# Florida Department of Environmental Protection

RE: Third Request for Additional Information  
Drilling Permit Application 1366  
Kanter Real Estate LLC, Kanter Well 23-2  
Broward County, Florida

## Request for Additional Information

**Representative Diagram of Strata near Site**

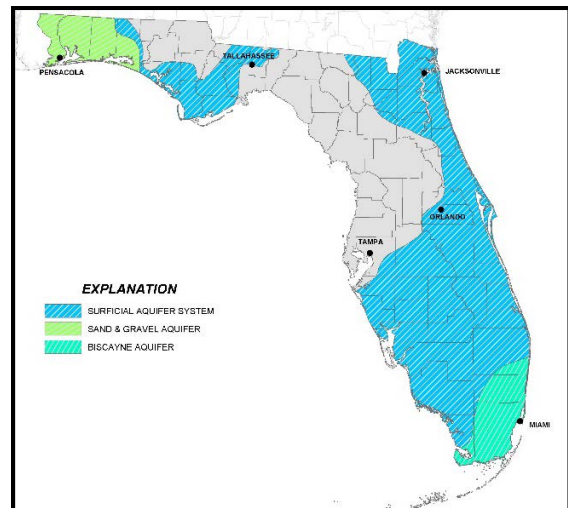
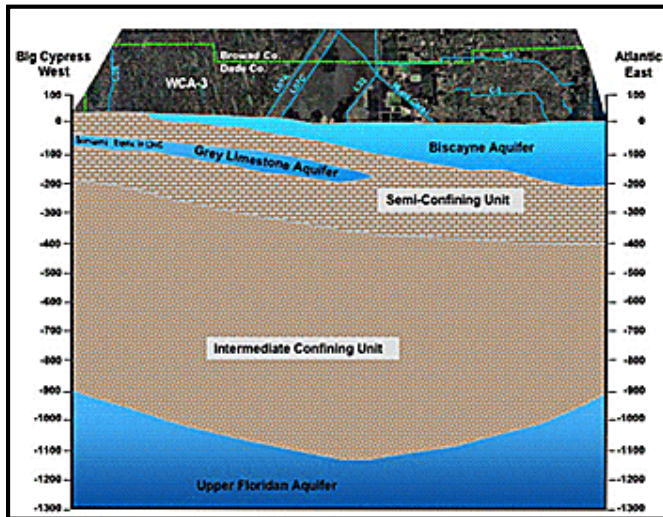
The diagram on the left suggests that the base of the Biscayne Aquifer is on the order of 50 feet below sea level (BSL) near the proposed site. The diagram also suggests the presence of another aquifer called the Grey Limestone Aquifer (GLA) within the Semi-Confining Unit (SCU) that underlies the Biscayne Aquifer.

1. Will the main drilling contractor/consultant responsible for the surface, intermediate and production casing/cementing programs also be responsible for setting the conductor casing? [377.22(2)(a), F.S. and 62C-27.005, F.A.C.]
2. Please explain, based on soils and prevailing shallow subsurface how the conductor can actually be driven 200 feet into the limestone without encountering refusal at a shallower depth. [377.22(2)(a), F.S. and 62C-27.005, F.A.C.]
3. Describe the measures that will be taken to prevent hydraulic connection between the Biscayne Aquifer and the possible GLA during setting of the conductor. [377.22(2)(a), F.S. and 62C-27.005, F.A.C.]

## WELLBORE SCHEMATIC

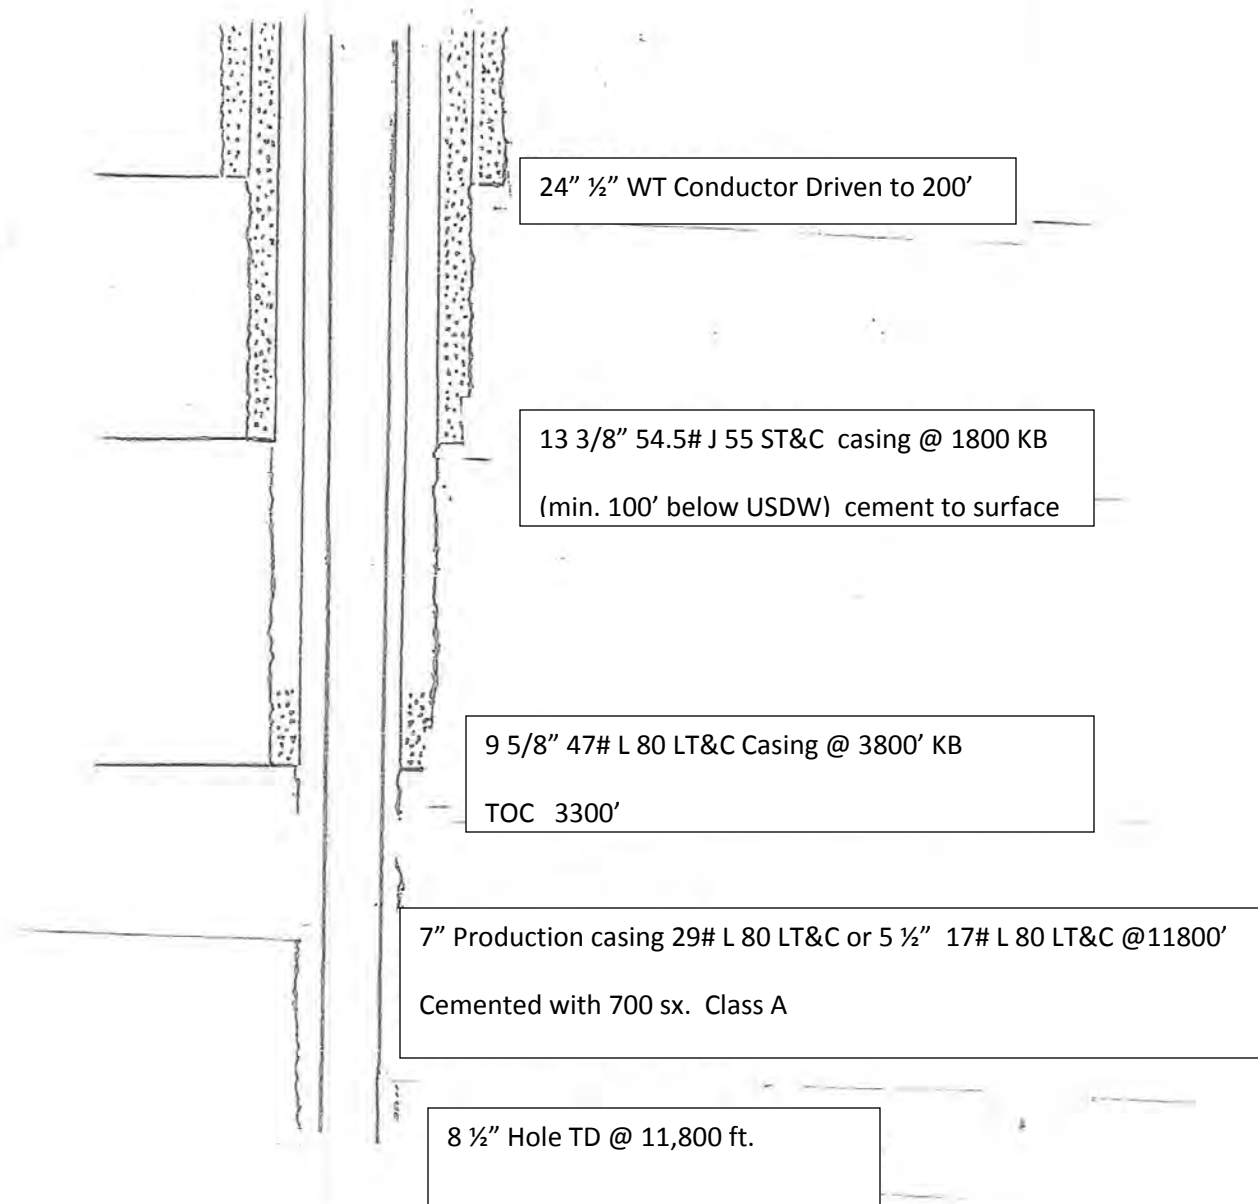
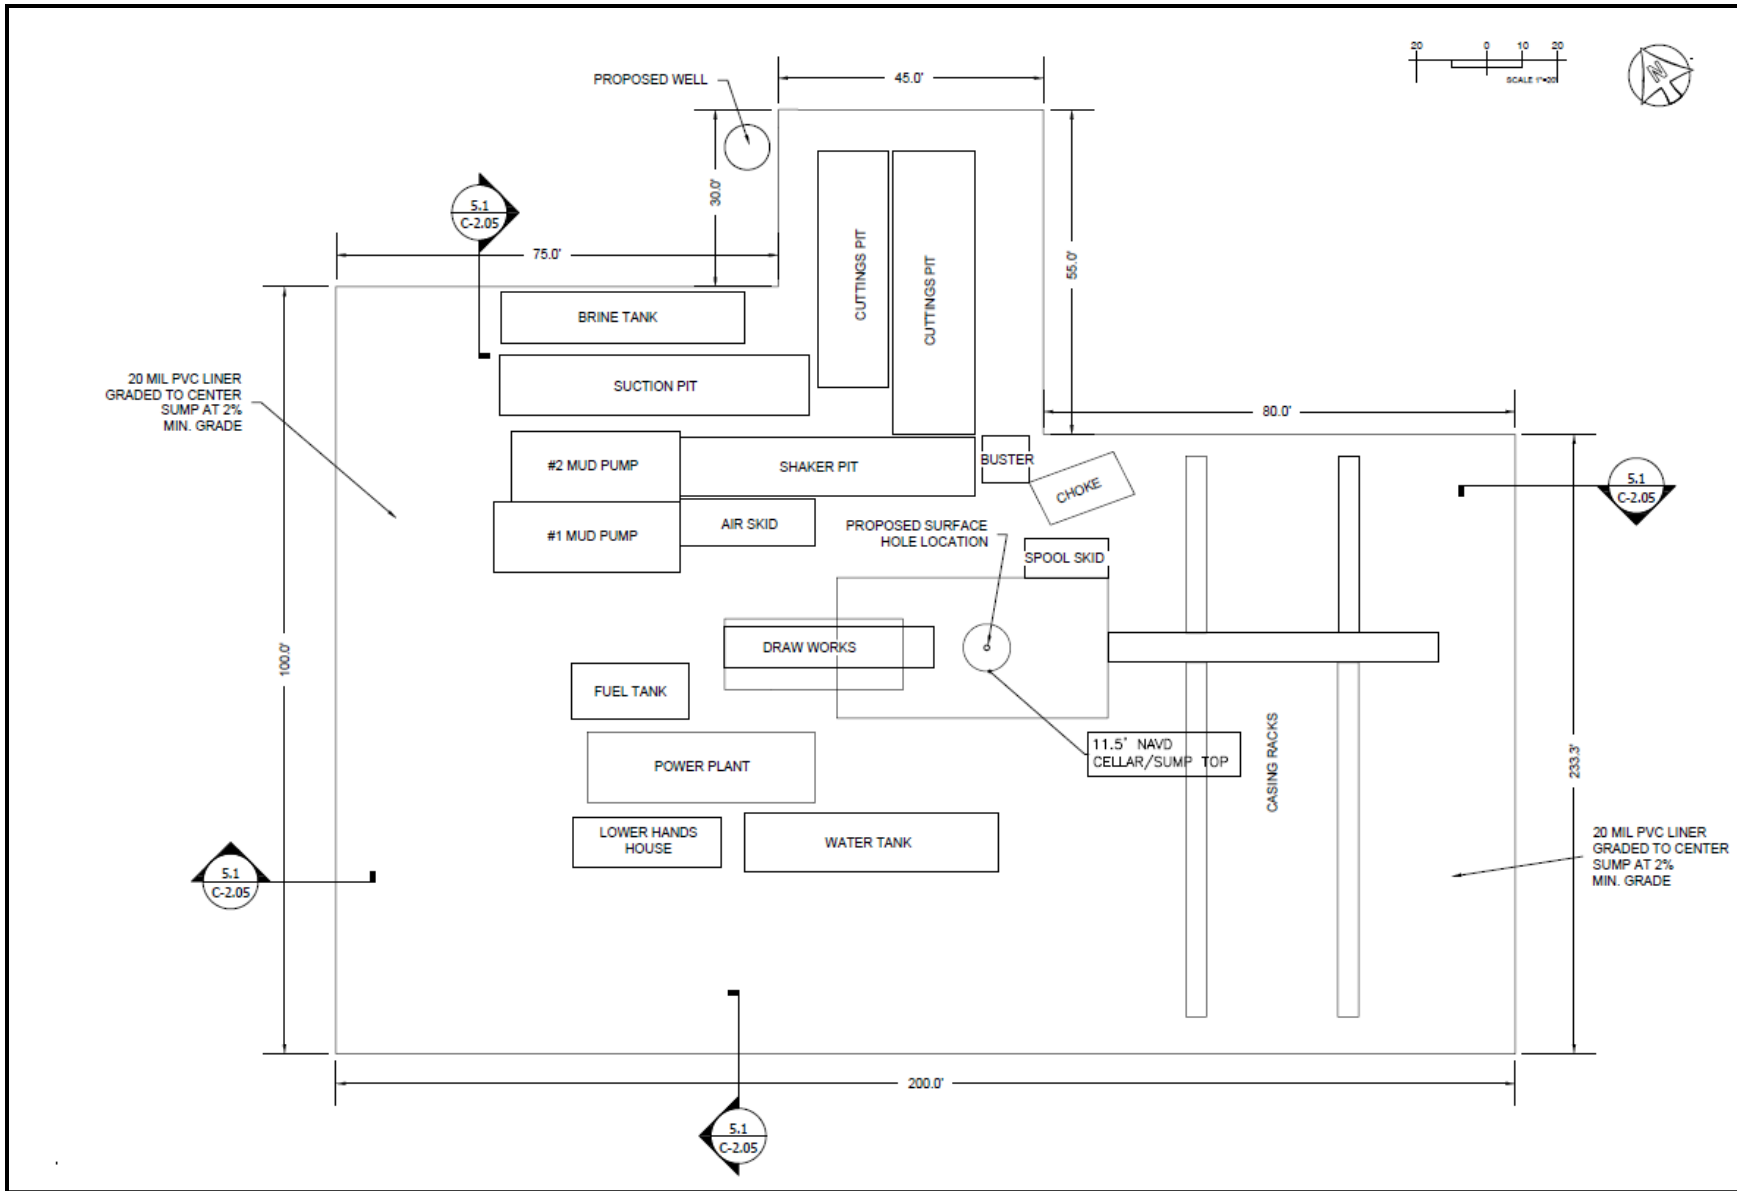
According to the wellbore diagram, the 13-3/8-inch surface casing will traverse the Biscayne Aquifer, the GLA, the SCU, the ICU and the UFA prior to landing in a competent confining unit below the deepest Underground Source of Drinking Water (USDW) and above the Boulder Zone.

4. Explain the measures that will ensure that water from the UFA will not enter the Biscayne Aquifer by direct connection or surface spillage. [377.22(2)(a), F.S. and 62C-27.005, F.A.C.]
5. How will the surface casing plan and mud/drilling fluids plan be modified if lost circulation zones are encountered when drilling the surface casing borehole through the limestone of the UFA? [377.22(2)(a), F.S. and 62C-27.005(1)(a), F.A.C.]

- In the submittal the surface casing is shown as being driven to 200 feet of depth, which is approximately 10' below the base of the surficial aquifer system. While drilling from 200 to 1,800 feet, and prior to setting casing, the resulting artesian head will need to be managed. What will prevent the upward migration (in the annular space between the casing and the borehole) of brackish to saline waters under pressure from below into the Surficial Aquifer system?

- USGS information and SFWMD staff analysis of existing information indicates the base of the brackish water zone (water less than 10,000 mg/L concentration) may be below 2,000 feet, requiring the 13 3/8" casing to extend to at least 2,100 rather than 1,800 feet. The use of resistivity logs as a methodology for confirming the base of the USDW may not provide an accurate estimate in a mudded borehole. How will the USDW be confirmed in the field?

- There is no specificity provided for managing potential lost circulation in high flow zones and artesian conditions that will be encountered in the upper and middle Floridan Aquifer System. Drilling with mud through the Upper Floridan Aquifer may potentially contaminate the aquifers by loss of circulation through flow zones.
